Grassroots Community Group of Alhambra

email subject line: DEIR Comments-The Villages at the Alhambra

Ref: Comments by Grassroots Alhambra (GRA) on the Draft Environmental Impact Report (DEIR) for the proposed Project titled “The Villages at the Alhambra”

Grassroots Alhambra (GRA), on its own and on behalf of its members, timely provides the following comments, due on October 17 before 5 PM, based on its review of the draft Environmental Impact Report (DEIR) for the project titled “The Villages at the Alhambra,” Case Number: RP-17-1, CU-17-9, V-17-10, V-17-11, & TT-74194, State Clearinghouse No. 2017101025 (hereafter, “Project”).

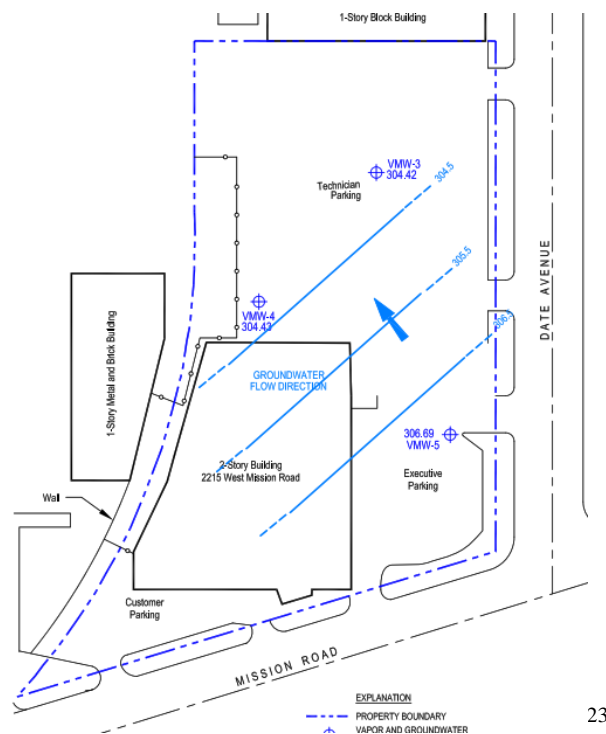
Finally, and just purely in order to illustrate the somewhat confusing and indifferent technical work pertaining to the geohydrology underlying the site, we excerpt from two figures provided as part of the revised Phase I Site Assessment. First is a figure excerpted below from a portion of the site showing that the groundwater flow at the site is towards the north-west (the blue arrow), based on an analysis of just the groundwater levels in the three indicated wells.

The next is an excerpt from a broader groundwater contour map, also part of the revised Phase I Site Assessment, shown below. Note the direction of groundwater flow, indicated by the red arrows – which indicate flow opposite to that shown in the Figure above. We believe the figure below is correct. By including “analysis” such as the figure above simply undermines the DEIR. We ask the City, as Lead Agency, to thoroughly vet what is being presented in the DEIR.
